From: [Tkachuk, Tyler](#)
To: [Von Holdt, Crystal L - DNR](#)
Cc: [Cunningham, Brian J - DNR](#); [Allness, Michele M - DNR \(Shelly\)](#); [Jim Schumacher](#); [Isaac Schrock](#); [Neeve, Kyle](#); [Larson, Zachary](#)
Subject: Requesting more info: Epic's West Road state application - Response
Date: Thursday, April 11, 2024 9:25:19 AM
Attachments: [West Road Temporary Crossings XS 240411.pdf](#)
[West Road Temporary Crossings 240411.pdf](#)
[Alternative 3.2 West Road Additional Restoration 240411.pdf](#)
[WDNR Responses Permit 240411.pdf](#)

This email is the teams response to your previous two emails with questions regarding the C. of Verona - West Road IP application. The PDFs include new exhibits as well as a question/response PDF combining previous questions from the WDNR.

ALTERNATIVE 3.2
EXHIBIT 3.2-6
ADDITIONAL RESTORATION

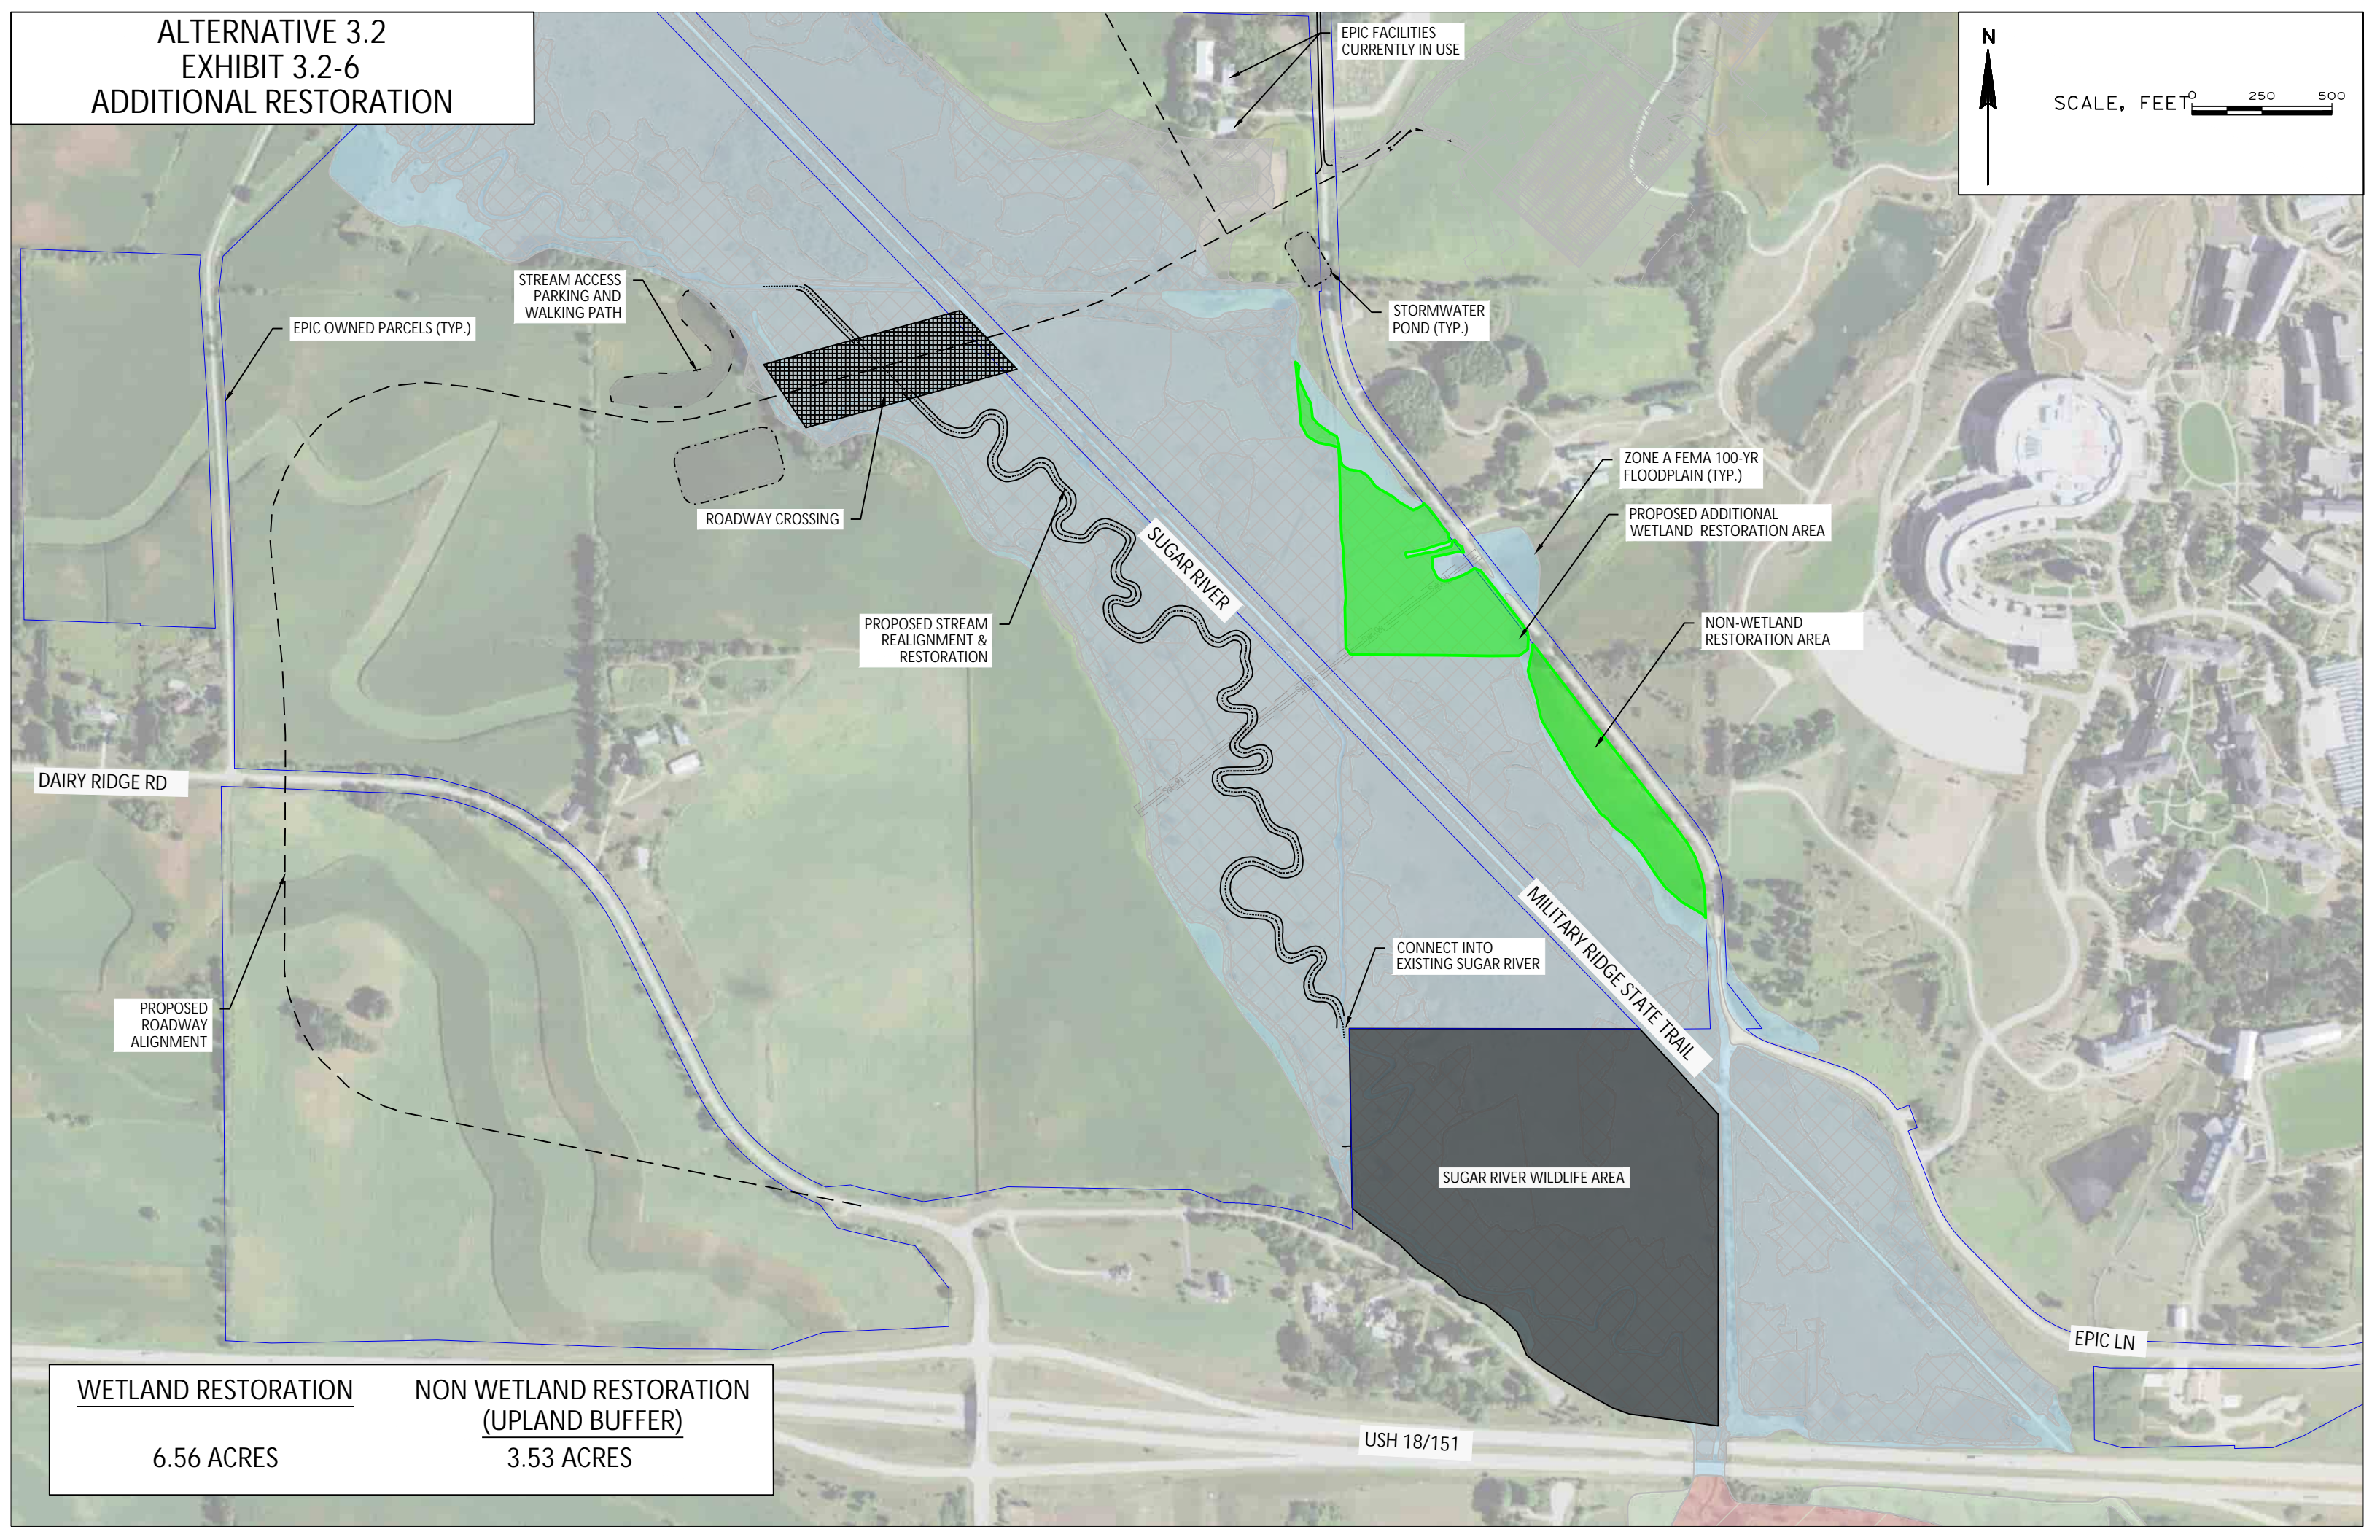
4. WETLANDS - BALANCING NET LOSS: In reviewing the thorough alternatives analysis and supporting delineation information, the Department sees a possible opportunity for wetland enhancement of approximately 7 acres along the river valley. The enhancement of an existing farmed wet meadow will help reduce the gap a little more to reach a balance closer to "no net loss".

- a. The farmed wet meadow (approx. 7 ac in size) located on the east bank and is at the location where the Southern Utility Crossing is proposed. If Epic is willing to stop farming (mowing) and establish native wetland vegetation in the field (approximately 7 acres), the overall permanent wetland impacts are better balanced with a 7-ac wetland restoration that returns a farmed, degraded wetland to a natural community with wetland functions and values.

- b. Please provide details on how Epic will work to re-establish a native wet meadow community in place of the farmed field.

The project will incorporate the 6.56 acres of farmed wet meadow as requested. A new exhibit was created to show this new area (Additional Restoration) and the addition of a new non-wetland restoration area (upland buffer) that is 3.53 acres. Please see exhibit [Alternative 3.2_West Road_Additional Restoration.pdf](#). The project will monitor the wetland plants for up to 2 years after construction is complete. Native wetland seed mix will be added to these areas.

WETLAND RESTORATION	NON WETLAND RESTORATION (UPLAND BUFFER)
6.56 ACRES	3.53 ACRES
